**RE: Case No. 18-1800-EL-BLN
Devola-Mill Creek 138 kV Transmission Line Project
Notice of Adjustments**

After consulting with OPSB Staff, AEP Ohio Transmission Company, Inc. (“AEP Ohio Transco”) provides the following notice of adjustment to the 0.4 mile Devola-Mill Creek 138 kV Transmission Line Project.

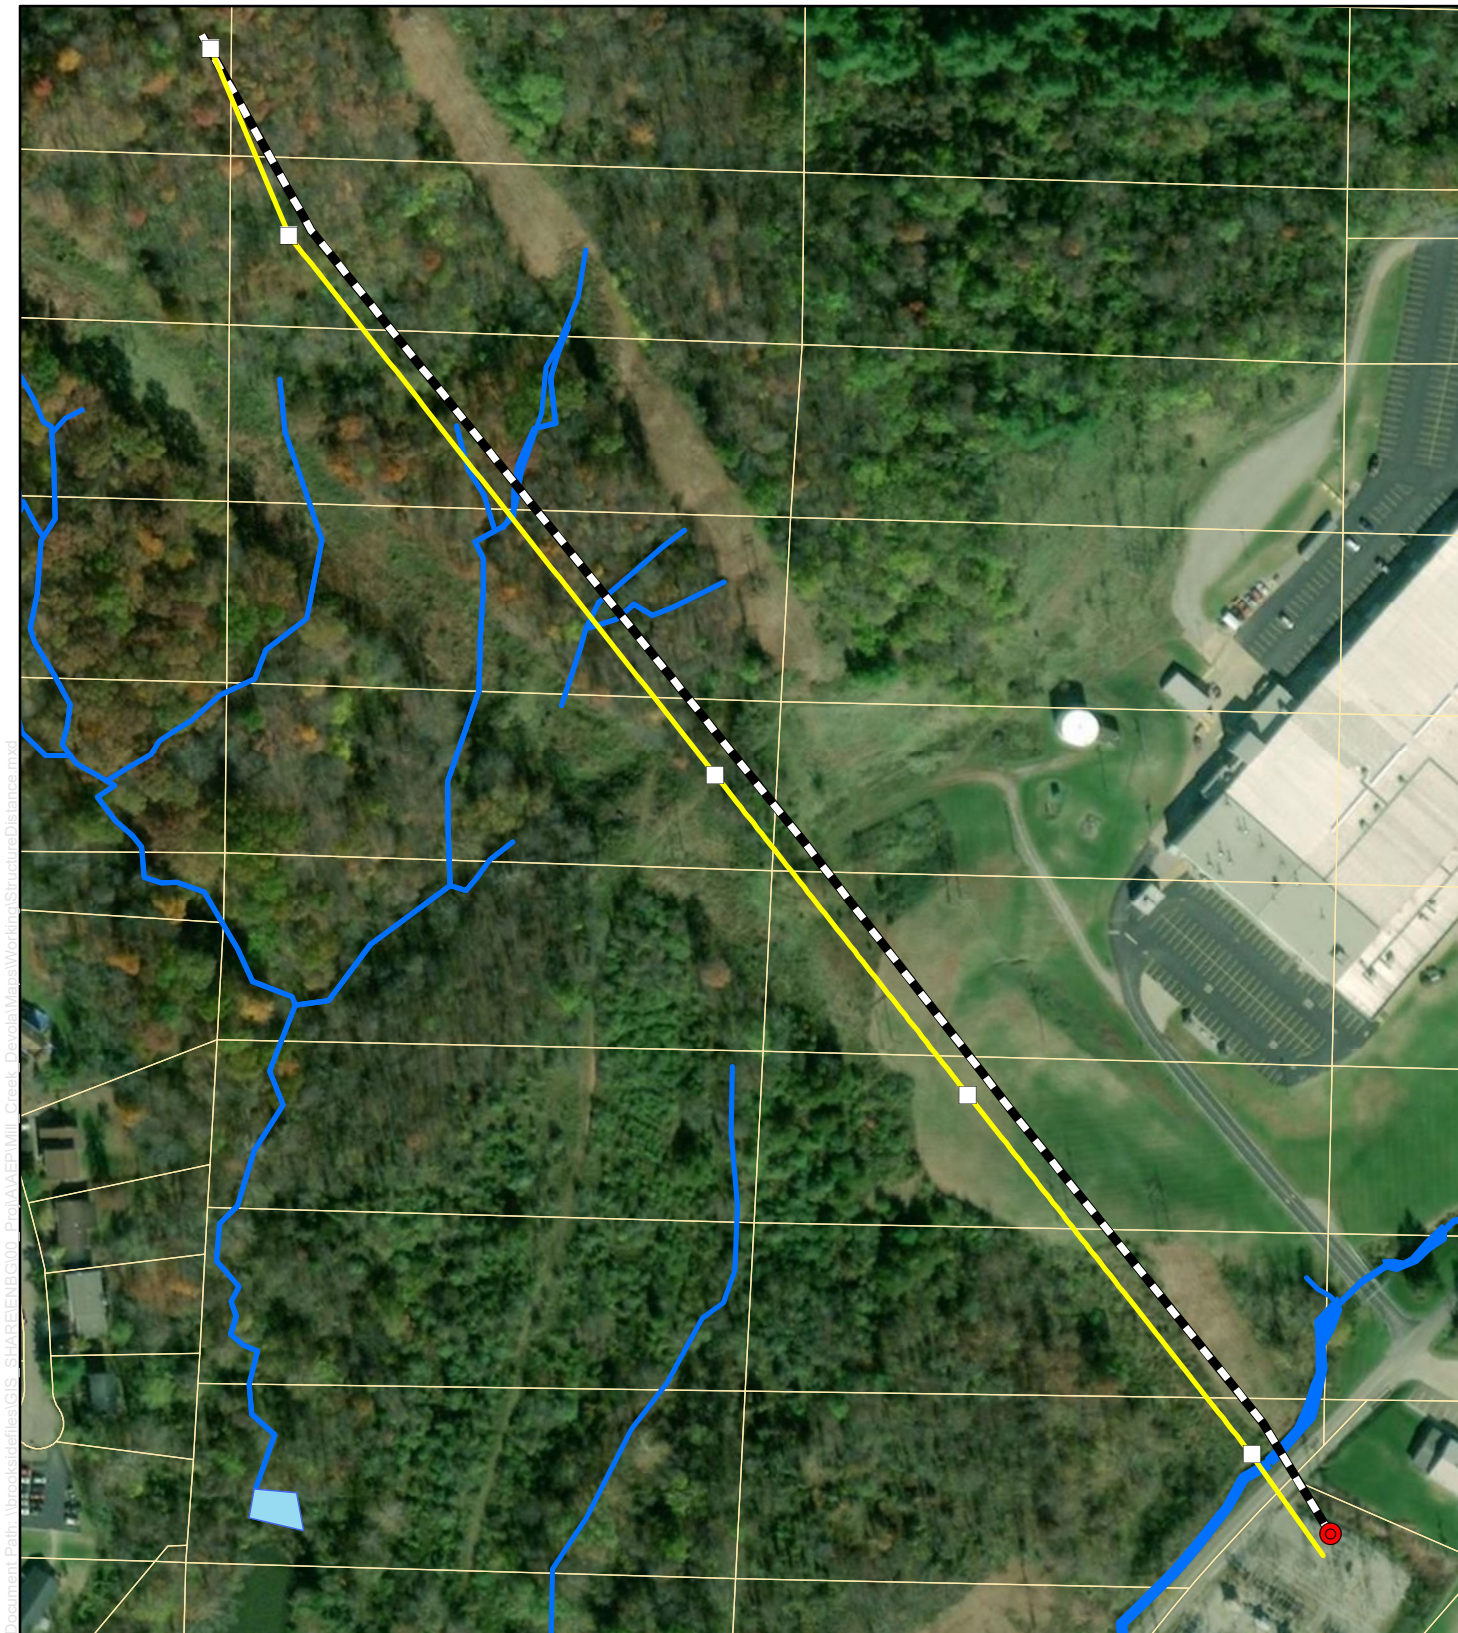
AEP Ohio Transco is shifting the centerline approximately 25-35 feet west and eliminating the need for distribution underbuild. This shift does not affect any new property owners or impact any additional wetlands or streams. Attached is a map showing the shifts.
